Subject: Proposed Rezoning - Old Sauk Road proposed development

sho; Eruhing, William; Parks, Timothy; All Alders; council; Planning; Horvath, Linda 610 -6706 Old Sauk Road Plan Commission Meeting on June 10, 2024, Legistar Nos, 82950, 82972, 8297

Traffic/Parking Issues for 6610 - 6706 Old Sauk Rd, Legistar 82950, 82972 and 82979, Please Post to Subject:

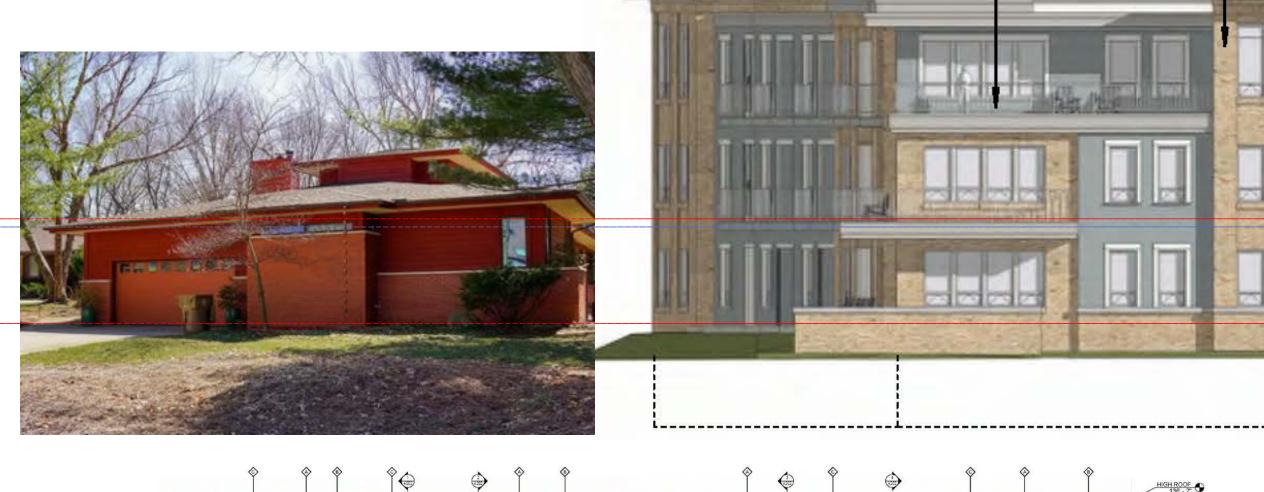
North West Stormwater Basin
The North West Stormwater Detention Basin is also of major concern. With the snow melt and spring rain or a heavy rain and the basin filling up, hydrostatic water pressure flowing through the sandy soil will flood existing homeowners' basements and lower levels on Torrey
Pines Court, Saint Andrews Circle as well as Spyglass Court. I mentioned this in my earlier comments on the October SH Proposal but these comments were not addressed. If water is going to be held on site in this area, an additional subsurface stormwater basin will need to
be considered in lieu of the Stormwater Detention Basin.

-r-many Stormwater Letention Basin
The Primary Stormwater Detention Basin to the west is of major concern. It is surprising that it is not a Retention Basin. I believe by ordinance, (Chapter 37 – Stormwater Management – Municode Library), it must be. In the event of a major rain event (greater than 200-year event) when the basin fills up, where does the stormwater go? It appears the stormwater works its way on the surface to Spyglass Court flowing over adjacent properties. This stormwater, complicated by the City's current watershed issues in this area and combined with a 500-year flood event, will significantly impact those home owners on Spyglass Court. When Subsurface Basins are full, typically there is a release of stormwater into a city owned stormwater system, this is not the case here. This proposal, if approved will flood adjacent homes and properties.

The construction of the basin along the north fence is also of major concern. As the soil in that area is sand, standard excavation is not possible as the sand will collapse back into the excavation. How are the basins going to be constructed? It appears sheet piling is going to have to be driven along the total length of the basin to hold be the basin to hold be the sand, in order to be able to construct the basins. Standard backfill exeavation is not appropriate for this basin placement. If piling is used, both my home and property will be damaged: piling location is about 15-20 from my blosser. For installation of piling will displace the store wall and potentially cause structural damage to my home.

-Watershed Summary
The developer needs to reassess the watershed strategy for this proposed development as the current proposal has many issues and concerns. The Watershed Plan needs to be constructed connecting into the City's existing Stormwater System; the Northwest Detention Basins will Bod arighton's basements; the Underground Basins will be a difficult installation, if not impossible to construct in the sandy soils; and the West Detention Area must be a retention basin with connection into the City's stormwater system.

2 SOUTH ELEVATION A201 1/16" = 1'-0"

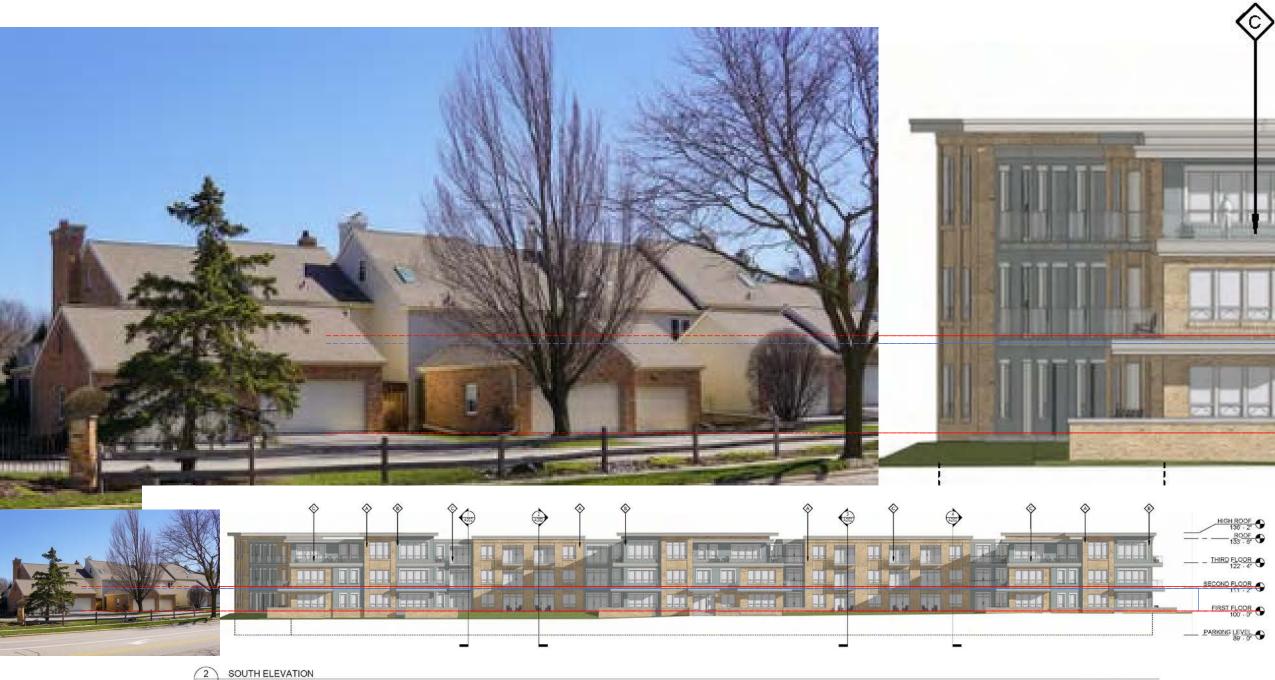
- The project would increase the risk of substantial flooding to neighborhood homes and yards.
 It would effectively establish a wall, 40 feet in beight and extending down Old Sauk Road to a size 19 times larger than the apartment building next door with a length significantly longer than a football field.
 The project would require the neighborhood to suffer from noise, air, and light pollution, seriously aggravated by the Stone House plan for a recreation area featuring a swimming pool, hot tub, sauna, fire pit, and bocce court.
 Please give this your most serious consideration and include it on all three Legistar files shown above.

- A. Ten architectural styles are represented in the housing on Old Sauk Road
- B. A majority of the residences are NOT characterized as modern or contemporary
- C. 97% of the residences have roofs that are NOT flat (flat roofs at 5702 and 6605 Old Sauk)
- D. Chapter 28 states that zoning exists to "create a sense of place." This development has no sense of place. The overall look is not homey; like the Lake View Sanatorium, it is institutional.

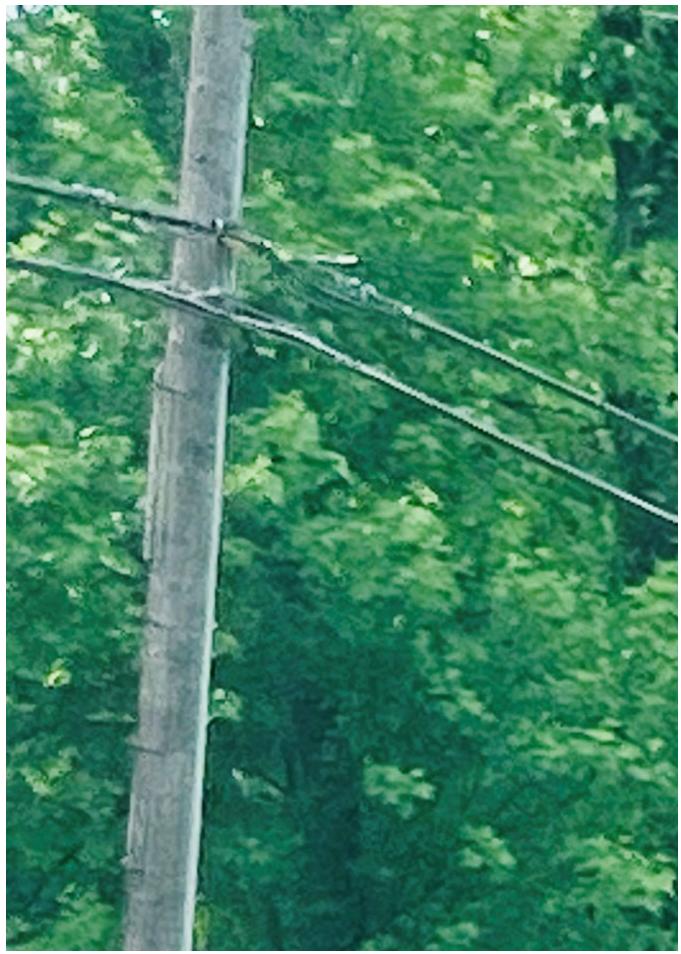
At the 3/13/24 Proposal Meeting, it was stated that renters would have to pay extra for parking spaces, leading to potential overflow onto the OSR and the side streets(Photo 1).

Similarly, San Juan Trail just across from the proposed project(Photo 2) would only allow one car to pass due to parked vehicles on both sides.

This could significantly narrow Old Sauk Rd, impacting visibility, its traffic flow and safety for buses, bicycles and cars. (Photo 3).
